# Proposal on removing standalone signaling header authentication

IEEE C80216m-09/0182r1

Topic: Security, standalone signaling header authentication

Figure 17 Functional Blocks of IEEE 802.16m Security Architecture

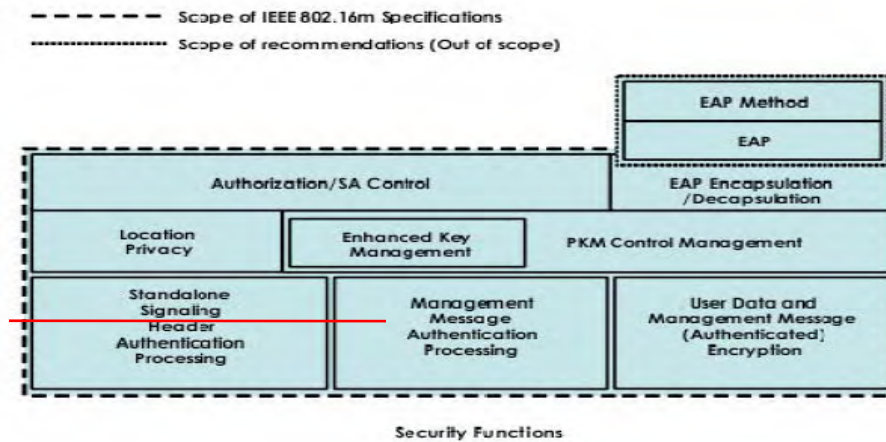
[ modify the following figure 17 in section 10.5.5.1 at page47 line 1]
